# Access Compliance Report

## Public Rights-of-Way

### (Curb Ramps)

Intersection ID: N/A	Main Street: GLENBURN_LN	Cross Street: KELYN_HILLS_DR	Location: NE
ADA ID: 8749EB372DE0	Ramp Type: PerpDiag	Initial Pass/Fail: Fail	Overall Compliance: No
Severity Score: 21.25			
Codes/Mitigation Info/Possible Solution		Field Measurements/Component Compliance

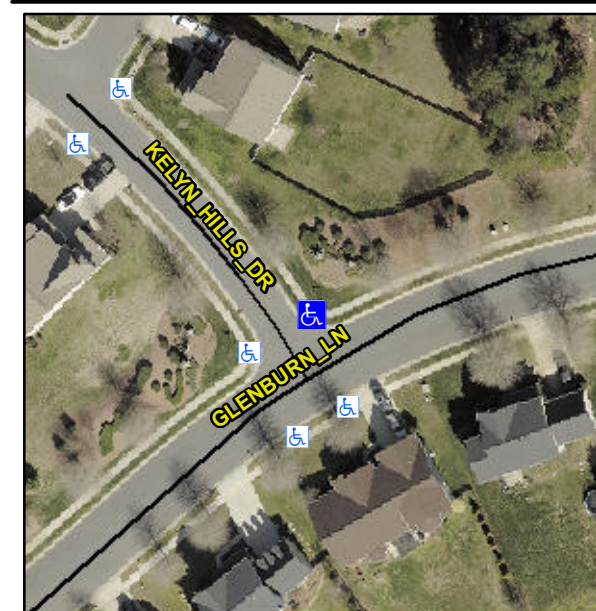
**Not Found, R304.5.1, R304.2.2**

Compliance	Description	Data	Compliance	Description	Data
N/A	Ramp Length (in)	45.0	No	Ramp Slope (%)	10.6
No	Ramp Width (in)	40.0	Yes	Ramp XSlope (%)	1.1
N/A	Flare Type LT	N/A	N/A	Flare Type RT	N/A
N/A	Flare Slope LT (%)	N/A	N/A	Flare Slope RT (%)	N/A
N/A	Flare Traversable LT?	N/A	N/A	Flare Traversable RT?	N/A
N/A	Landing Length (in)	N/A	N/A	DWS Provided?	N/A
N/A	Landing Width (in)	N/A	N/A	DWS Contrast?	N/A
N/A	Landing Slope (%)	N/A	N/A	DWS Length (in)	N/A
N/A	Landing X Slope (%)	N/A	N/A	DWS Full Width?	N/A
N/A	Landing Curb? (Y/N)	N/A	N/A	DWS Offset (in)	N/A
N/A	Shared Landing?	N/A			
N/A	Gutter Ponding?	N/A	N/A	Gutter Slope (%)	N/A
N/A	Gutter Lip Ht (in)	N/A	N/A	Gutter X Slope (%)	N/A
N/A	Painted X Walk1?	No	N/A	Painted X Walk2?	No
	X Walk 1 Direction	To SW		X Walk 2 Direction	To SE
N/A	X Walk 1 Width (in)	N/A	N/A	X Walk 2 Width (in)	N/A
	X Walk 1 Slope (%)	6.2		X Walk 2 Slope (%)	5.5
	X Walk 1 X Slope (%)	1.4		X Walk 2 X Slope (%)	7.1

**Remove & Replace Curb Ramp With Two New Directional Ramps or Equivalent.**
